From: [Miller, Ed](#)
To: jhr@nei.org
Subject: FW: Files from meeting Dec 14
Date: Friday, December 14, 2012 6:21:32 PM
Attachments: [Dam Failure Rev E Combined Comments - FFTF Input From Meeting.docx](#)

Attached is the NEI dam failure white paper that includes comments received from the December 14, 2012, public meeting.

POST-FUKUSHIMA NEAR-TERM TASK FORCE RECOMMENDATION 2.1
Supplemental Guidance for the Evaluation of Dam Failures

Figure 1 – Example Illustration of Dam Failure Evaluation Screening Approach (Method 3)

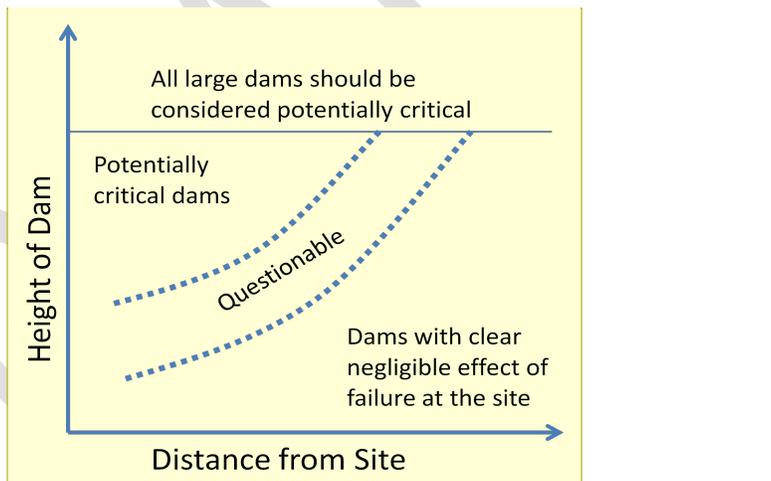
Comment [JFK67]: How to establish peak outflow from cluster? Add individual peak outflows? With or without attenuation?
 FTF –add individual flows at site with attenuation as described in method 3

Comment [MB68]: It is still not clear how the “large dams” threshold will be drawn.
 In addition, it is necessary to compare this relationship (which is chosen here because it facilitates plotting in 2D) with other available relationships. Only considering height and distance may not be enough (as noted in ANS-2.8, “some [dams] may be eliminated from further consideration because of low differential head, small volume, distance from plant site, and major intervening natural or reservoir detention capacity.” Height and distance doesn’t capture all those factors.)
 FTF –the figure will be deleted. The additional explanation and the appendices make the figure unnecessary.

Figure 2 – Example Illustration of Dam Failure Evaluation Screening Approach (Method 4)

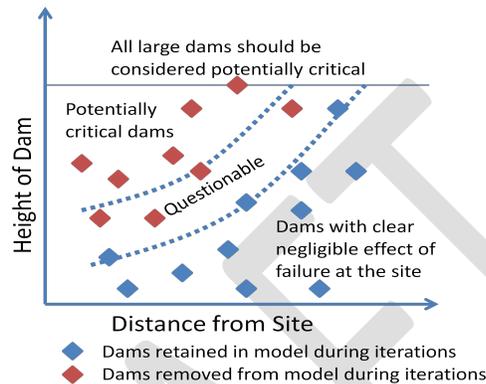
Comment [JFK70]: the dams are real, but their properties are assumed.
 FTF –the approach assumes hypothetical dams to take the place of the volume and height of multiple small dams

Comment [JFK71]: The dams are not hypothetical, but their properties are.
 FTF –see above. This approach uses hypothetical or representative dams.

Figure 3 - Approach to Hydrologic Failure Evaluation

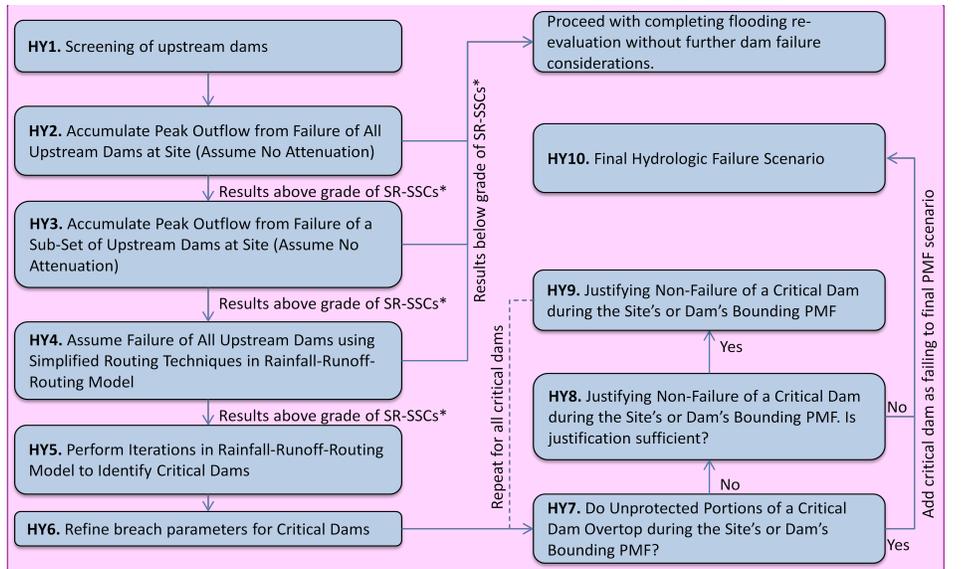
Comment [JFK80]: HY8 Text could be simplified to this question: Does engineering evaluation demonstrate dam safety?
 HY9 can be say "Do not model dam failure"
 FTF –OK

Comment [KSE81]: In HY-3 volume is not conserved?
 FTF –we are using peak outflow. Volume does not necessarily enter into concern when you are below grade

Figure 4 - Approach to Seismically-Induced Failure Evaluation

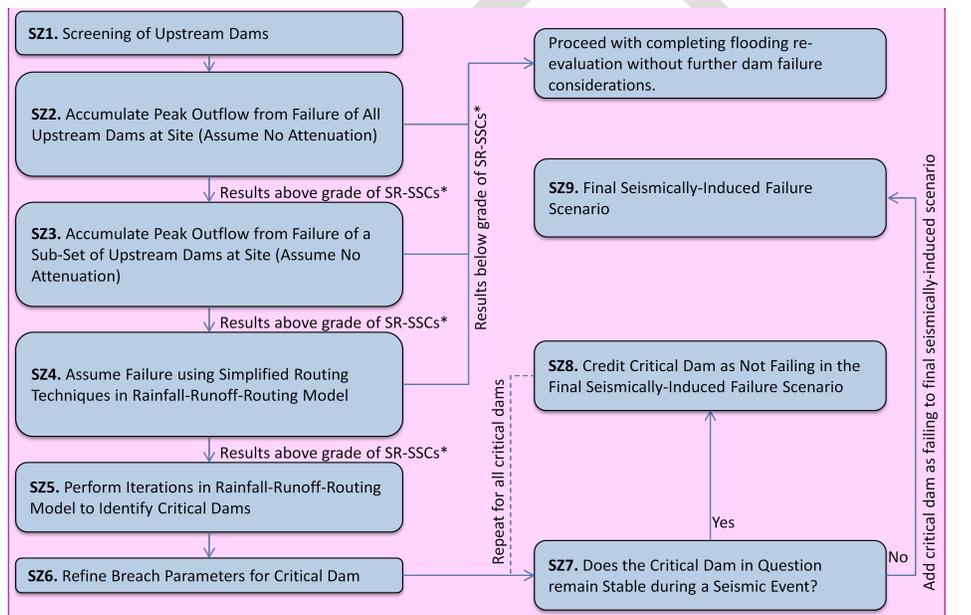
Comment [KSEE105]: In SZ-3 volume is not conserved.
 FTF --need to discuss the comment, not sure of the intent

Figure 5 - Approach to Sunny-Day Failure Evaluation

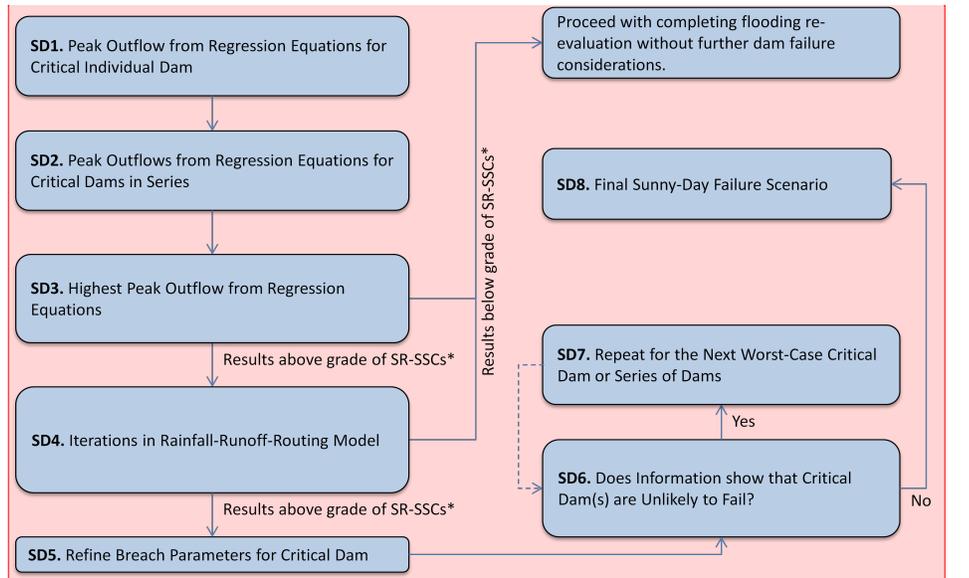
Comment [JFK130]: SD4 could be split into two pieces:
 SD4.1 – apply attenuation to dams from SD3
 SD4. Do the iterations if SD4.1 resulted in flooding above grade of SR-SSCs.
FFTF –OK will add a step between 3 and 4 to consider attenuation

Figure 6 - Peak Outflow as a Function of Height of Water behind Dam (Pierce 2010)

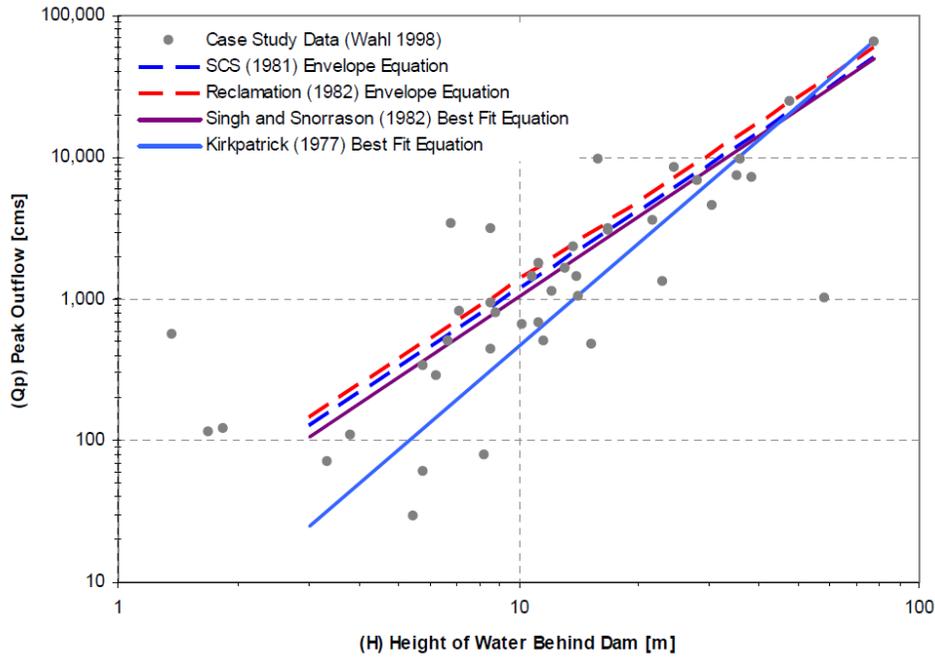
Comment [JFK153]: Not sure this figure is needed. It's not really discussed much.
FFTF – this is illustrative and was added to address comments from T Wahl. This should be kept in.

Figure 7 - Peak Outflow as a Function of Dam Factor (Pierce 2010)

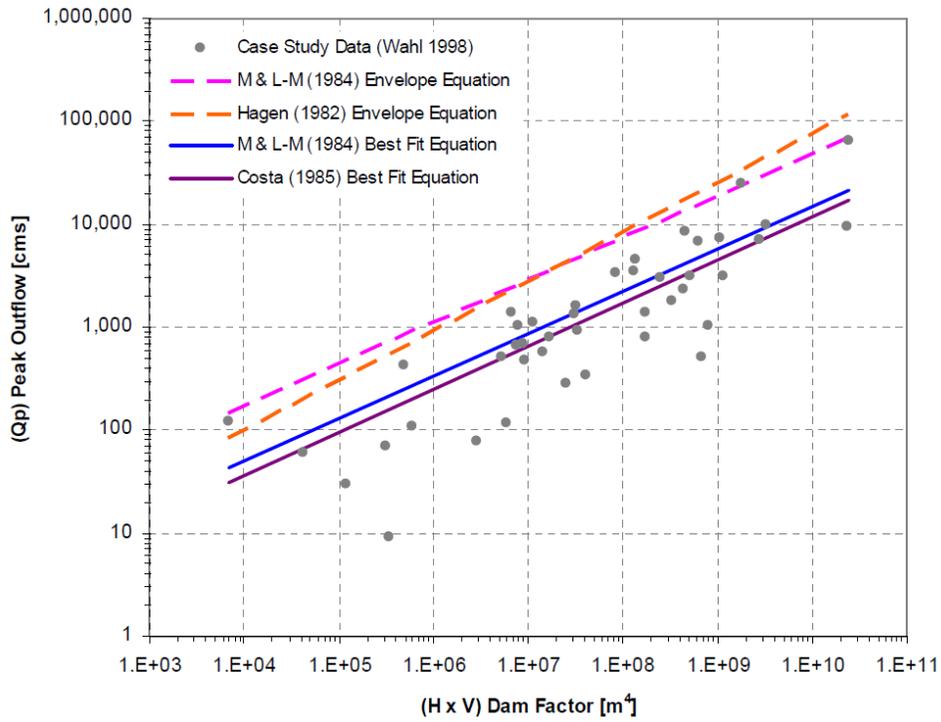
Comment [JFK154]: Consider removing figure. FTF – this is illustrative and was added to address comments from T Wahl. This should be kept in.
